Subject: Reponses to Information Requests for Formal Consultation for the Mariposa Energy

Project, Alameda County, California (USACE Identification No. SPK-2009-01261)

(USFWS Reference No. 81420-2009-TA-1306-1)

Reponses to Information Requests for Formal Consultation for the Mariposa Energy Project, Alameda County, California

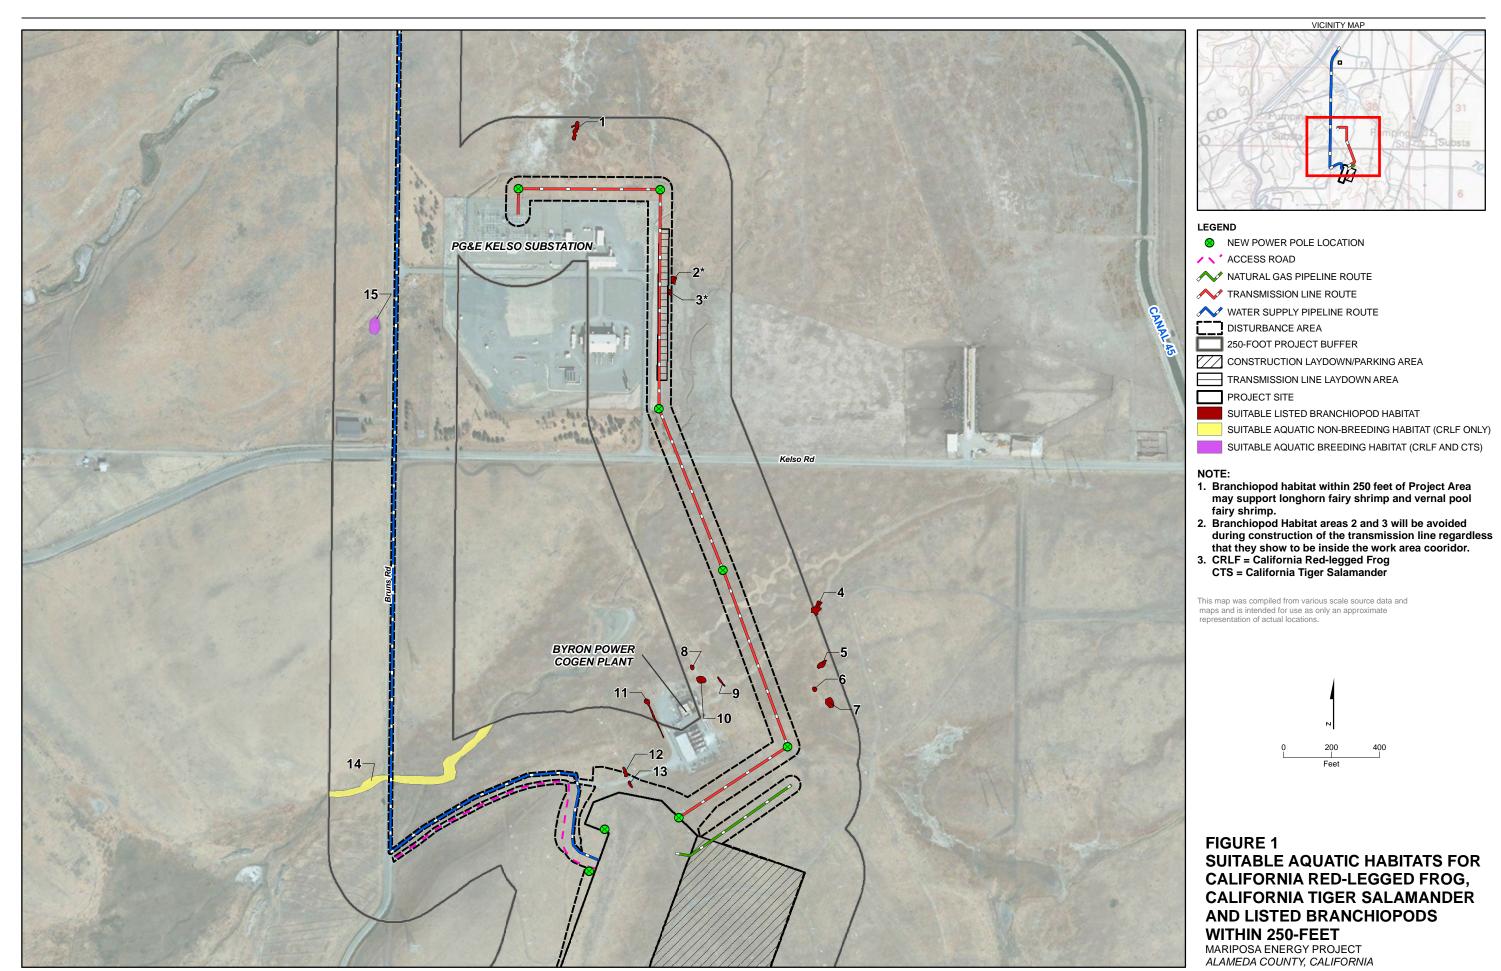
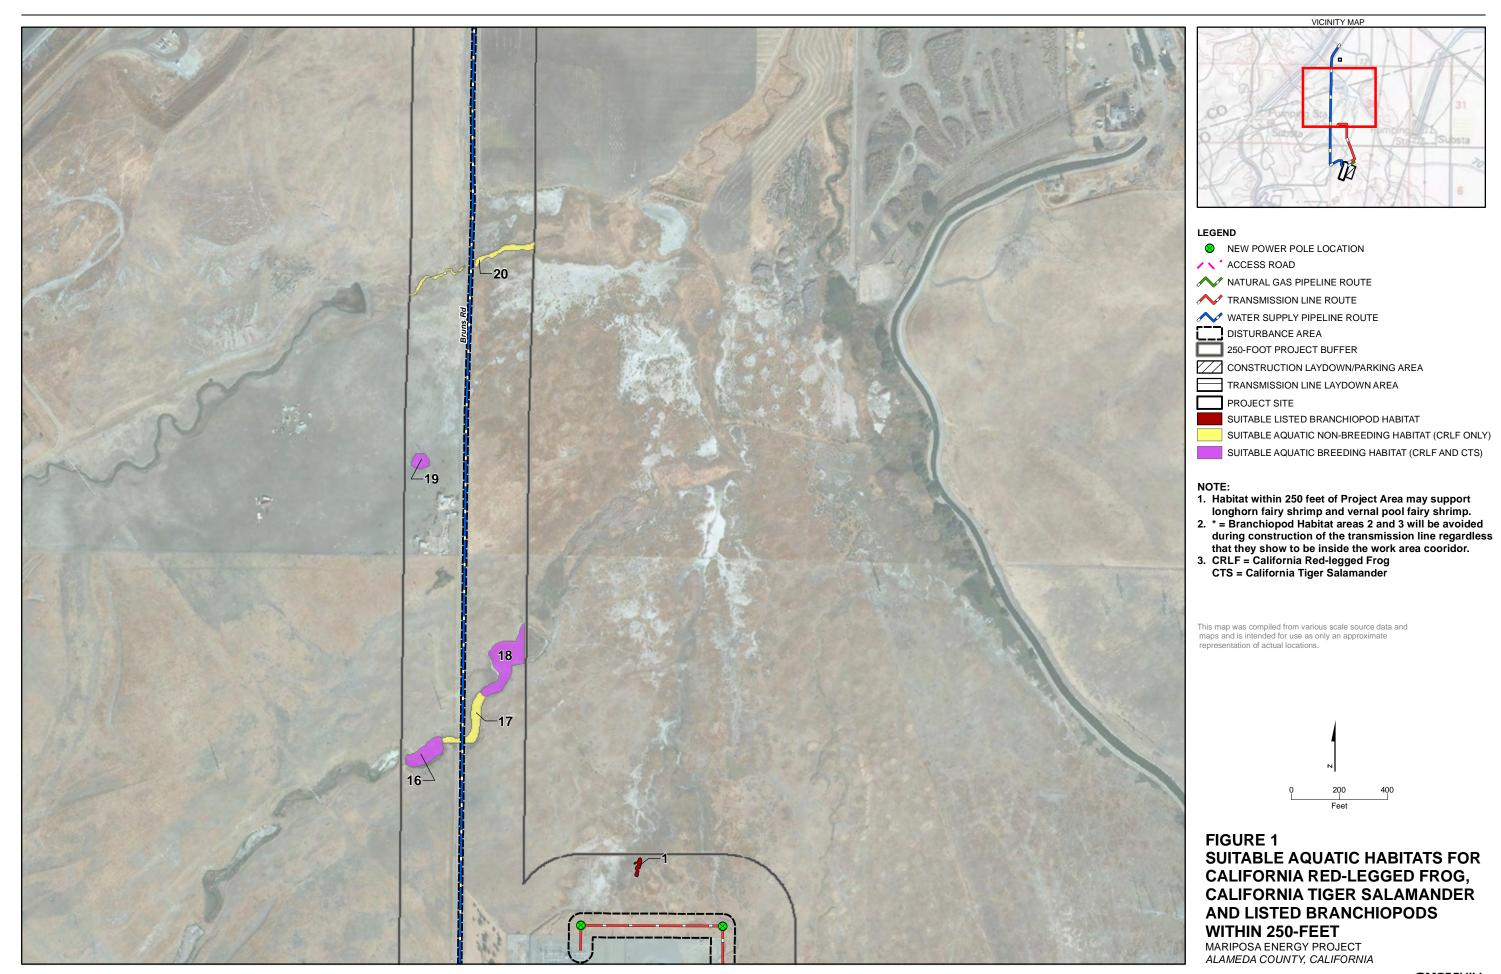
2. Section 2.1.4.6 describes construction access and states that all nearby wetlands will be avoided. How will they be avoided and by what distance? Does this avoidance include indirect effects of construction, runoff, and contaminants into the wetlands, as well as, the direct effects of vehicle traffic and road construction? Contrastingly, Table 6-1 states that 0.5 acre will be temporarily affected. Please clarify.

4. Please describe the actions and the effects of those actions that will occur within 250 feet of listed branchiopod habitat as mentioned in section 5.1.5.

There are wetlands and other waters within 250 feet of the Project that are considered suitable habitat for California red-legged frog, California tiger salamander, and listed Branchiopods. Each aquatic area shown in Figure 1 was assigned an identification number, which corresponds to the habitat description provided in Table 1 (Branchiopods) and Table 2 (California red-legged frog and California tiger salamander), located at the end of this memorandum.

With the exception SWL-1 (see Table 1, #12 and #13), wetlands and waters suitable for California red-legged frog, California tiger salamander, and listed Branchiopods will be avoided. Construction perimeter fence (e.g., orange snow fence) and/or wildlife exclusion fencing will be installed at the greatest distance feasible from these wetlands to discourage site workers, vehicles, and construction machinery from straying offsite into the aquatic habitats. An onsite biological monitor will also be present to advise all site workers to stay inside approved work areas at all times.

Please also refer to Response #2 above for a description of the actions and effects of those actions that will occur within 250 feet of listed Branchiopod habitat. Figure 1 shows the locations of all suitable Branchiopod habitat that could be directly or indirectly affected by the Project.

In summary, construction of the approximately 10-acre facility site and transmission line will occur within 250 feet of suitable branchiopod habitat (Figure 1). Disturbances will include initial clearing and grubbing of annual grassland vegetation, grading to level work areas as-needed, cut and fill across the MEP site to establish the facility grade, major sub-excavations for underground facilities including but not limited to pipelines, electrical conduits, and concrete foundations, and construction new above ground facility infrastructure. During construction of the project transmission line, utility line trucks, boom trucks, cranes, and light-duty trucks will drive and park within 250 feet of branchiopod habitat daily along the route. Soil disturbance along the transmission line will occur at the new monopole locations only when concrete foundations are installed. Otherwise, overland travel within the transmission line work corridor will be the predominant disturbance type. Water and gas pipeline construction activities were previously described in Response #1.
